January 24, 2024
AVO 37449

Re: **Marley Meadows – Drainage Study in support of the Final Plat**
3rd Review

CIVIL PLANS FOR MARLEY MEADOWS SAM BASS ROAD SANGER, TEXAS

SANGER, TEXAS
GRADING PLAN
FOR
MARLEY MEADOWS

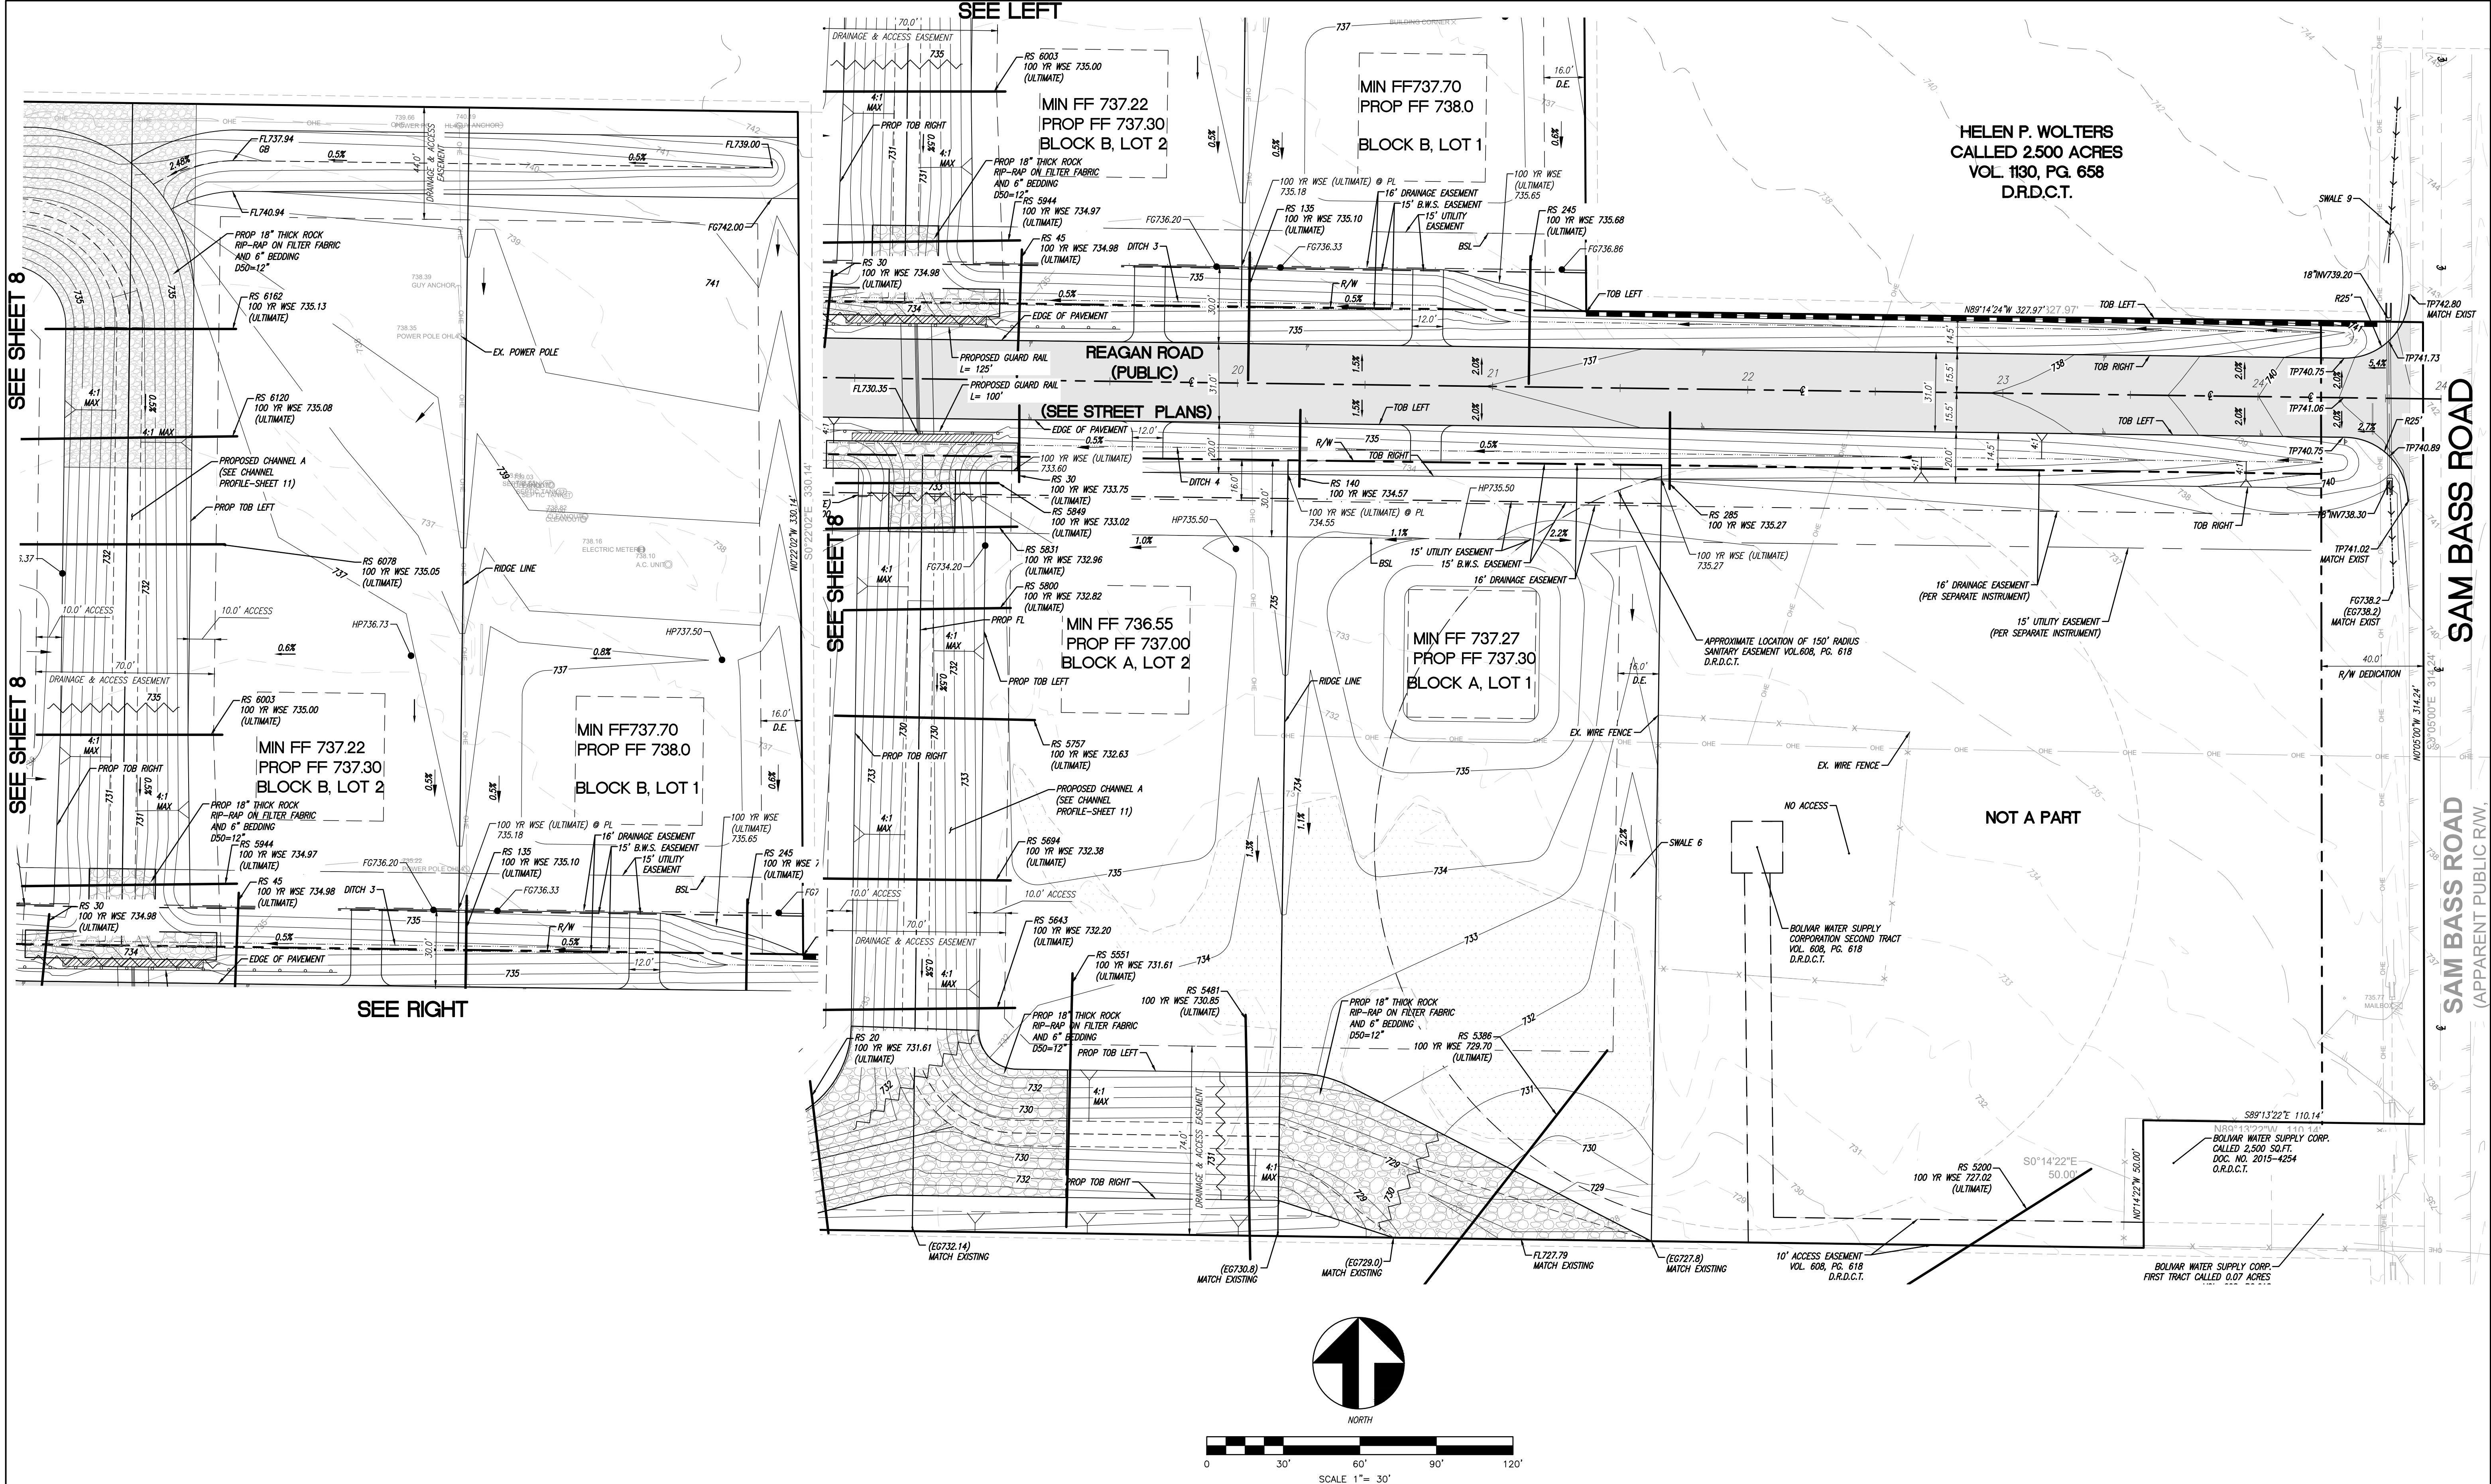
12. Please ensure side yard swales contain the 100yr WSEL and do not drain to the adjacent lots. Provide a typical section with hydraulic parameters. Ensure the typical section is feasible in each of the lots according to the grading plan.
1st Review Response: side ditch sized to contain 100 yr discharge
2nd Review Comment: Address side yard swales comment on grading sheets (sheet 8)
2nd Review Response:
3rd Review Comment: Addressed.

SANGER, TEXAS
HYDRAULIC WORK MAP
 FOR
MARLEY MEADOWS

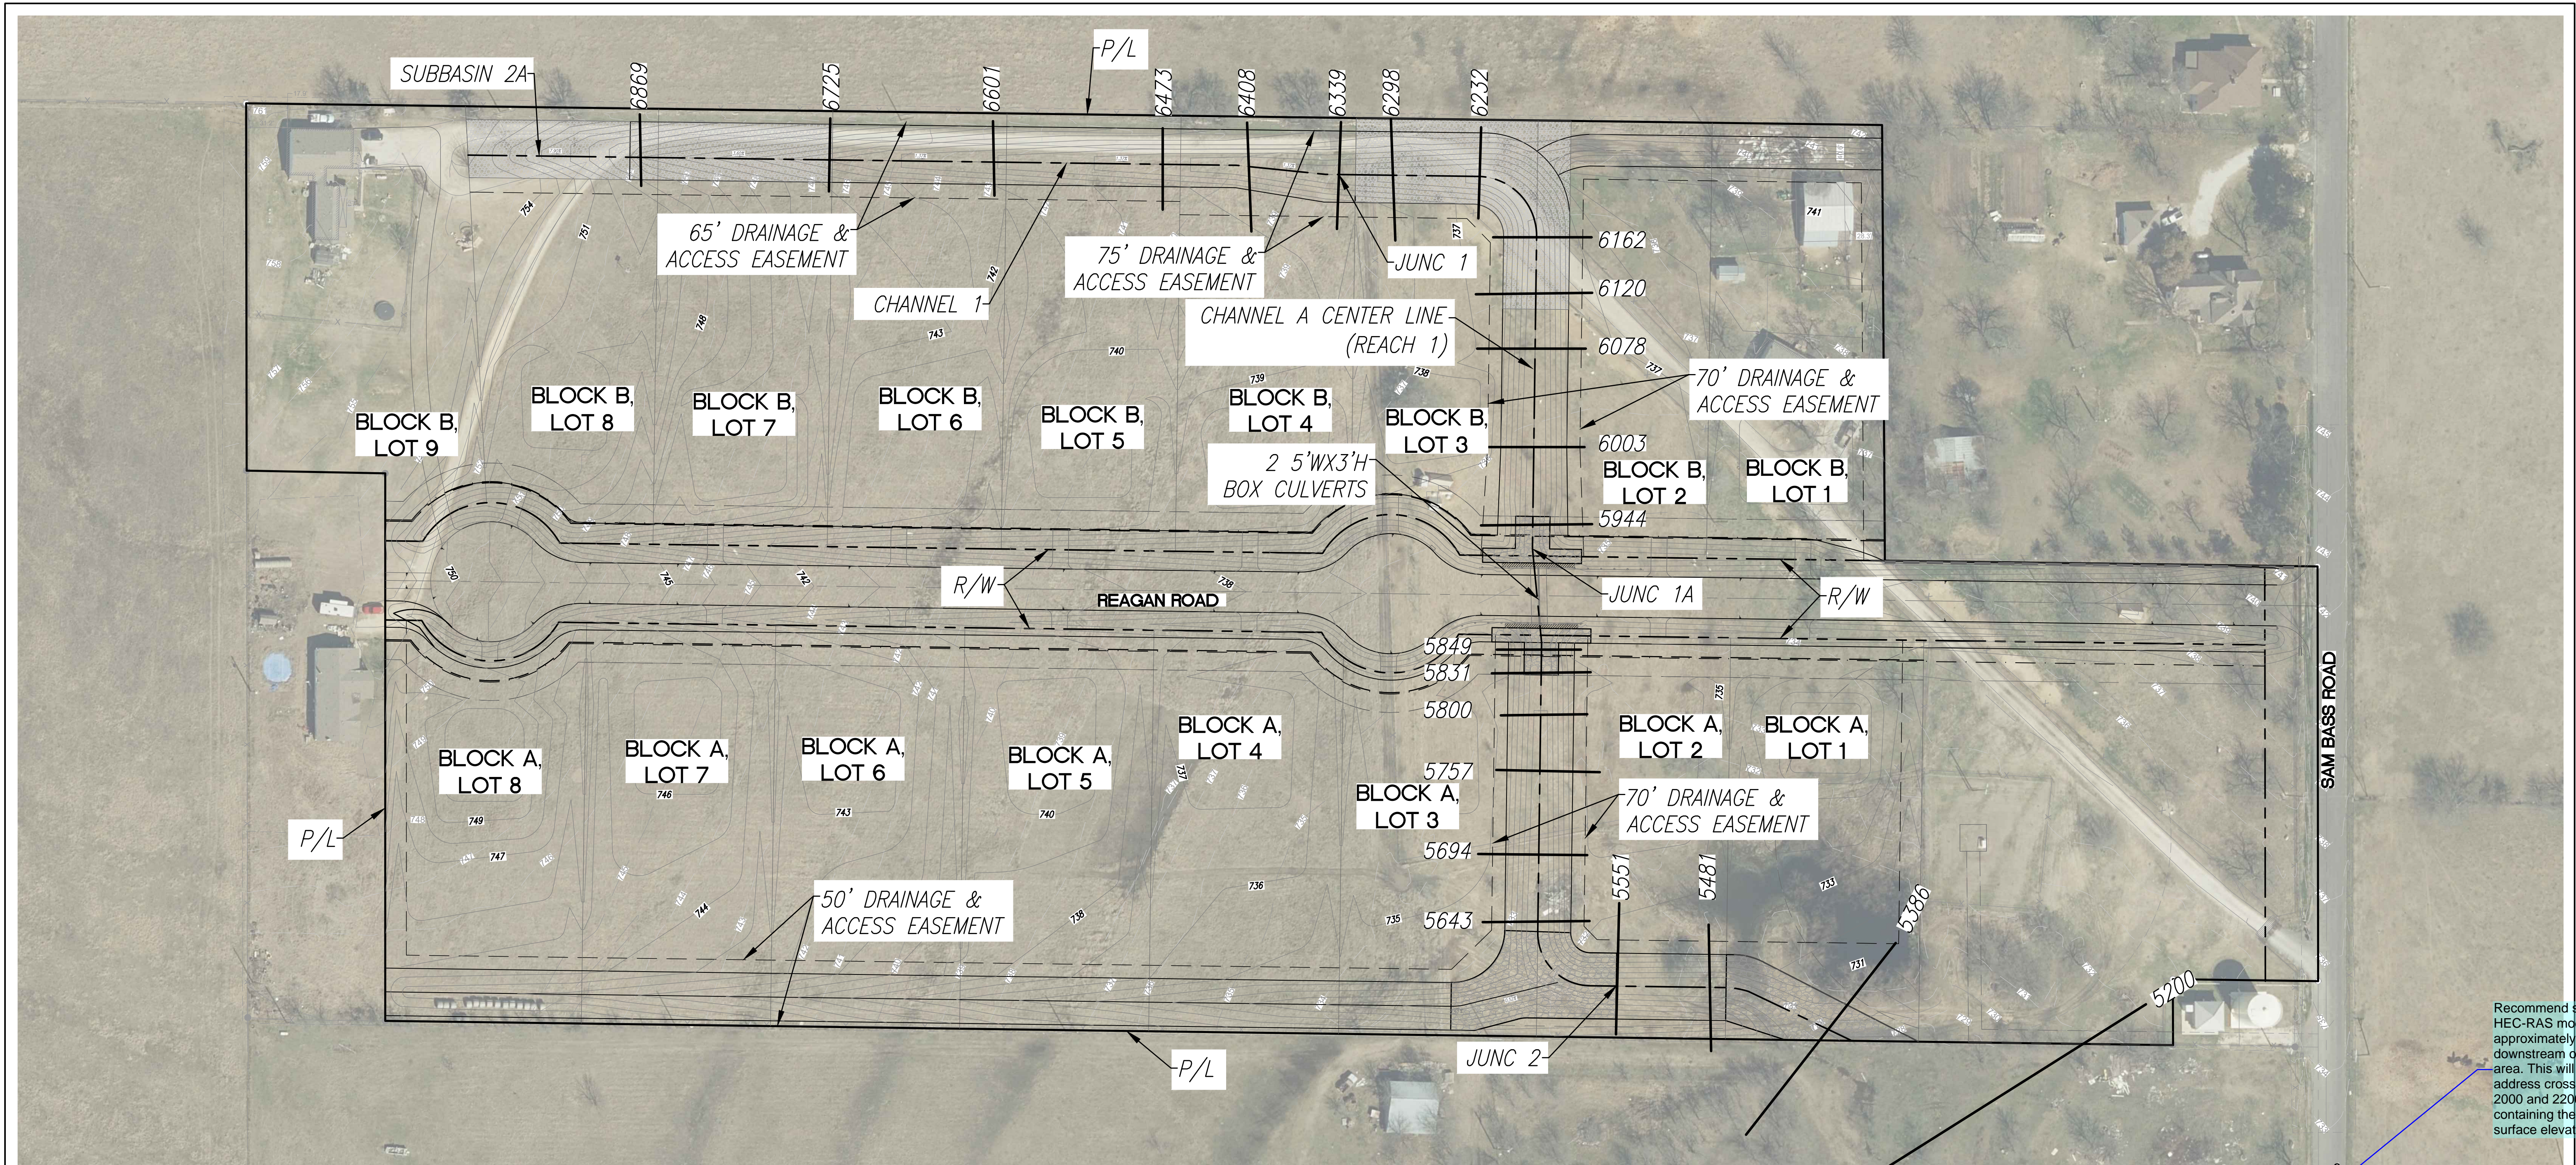
Recommend starting HEC-RAS model approximately 1,000 ft downstream of project area. This will also address cross sections 2000 and 2200 not containing the water surface elevation.

HEC-RAS model: N-values should be defined for the left overbank, channel, and right overbank at a minimum. One (1) n-value should not be used for the entire length of the cross section.
